MICROCHIP PIC18F8720/8620/6720/6620

PIC18F8720/8620/6720/6620 Rev. A4 Silicon/Data Sheet Errata

The PIC18F8720/8620/6720/6620 parts you have received conform functionally to the Device Data Sheet (DS39609B), except for the anomalies described below.

FIGURE 26-3: PIC18F6620/6720/8620/8720 VOLTAGE-FREQUENCY GRAPH (INDUSTRIAL, EXTENDED)

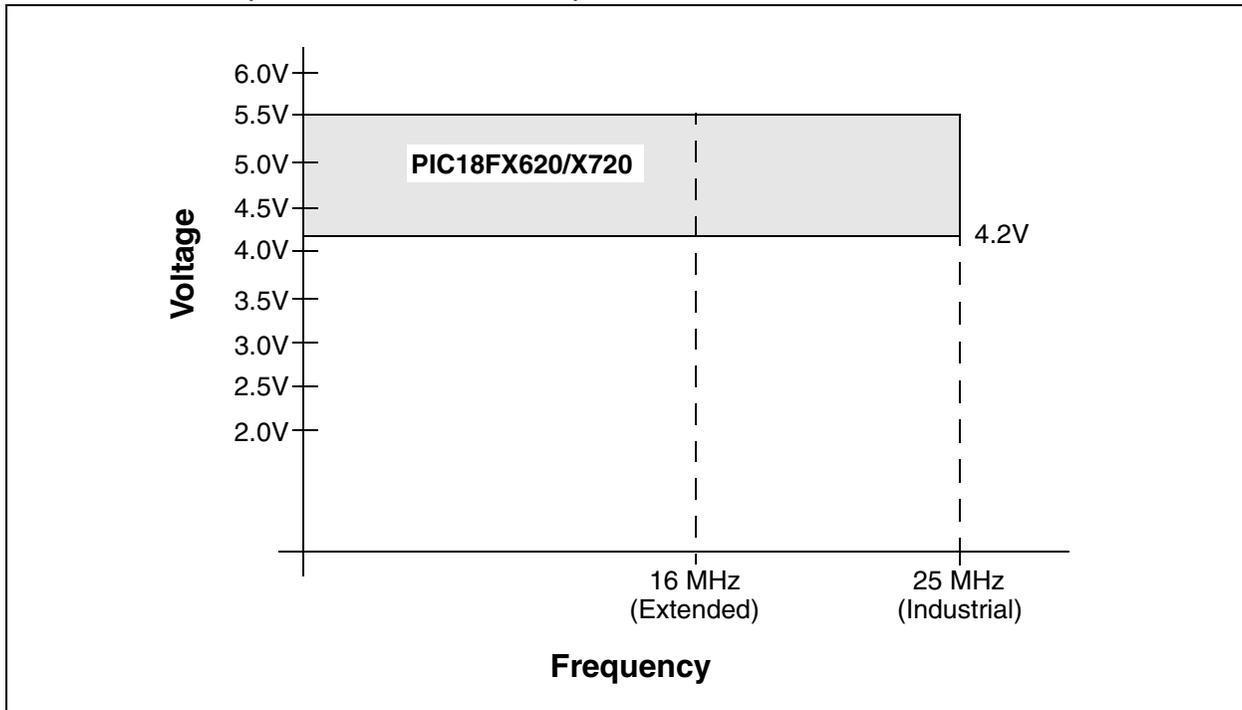
1. Module: Voltage-Frequency Graph

In Section 26.0 “Electrical Characteristics”, the following figure has been updated to clarify the voltage frequency for Extended devices.

FIGURE 11-1: TIMER0 BLOCK DIAGRAM IN 8-BIT MODE

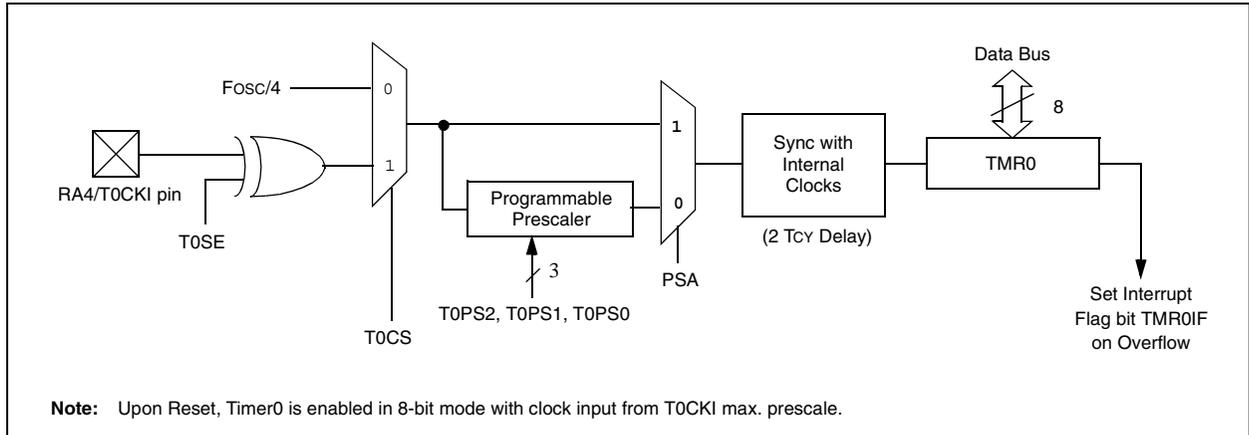
10. Module: Timer0 Block Diagram in 8-Bit and 16-Bit Modes

The PSA multiplexor bit values in Figures 11-1 and 11-2 do not match the text description of the Timer0 PSA bit in the T0CON register.

The bit values have been corrected by swapping the values as shown below (correct values are shown in **bold text**):
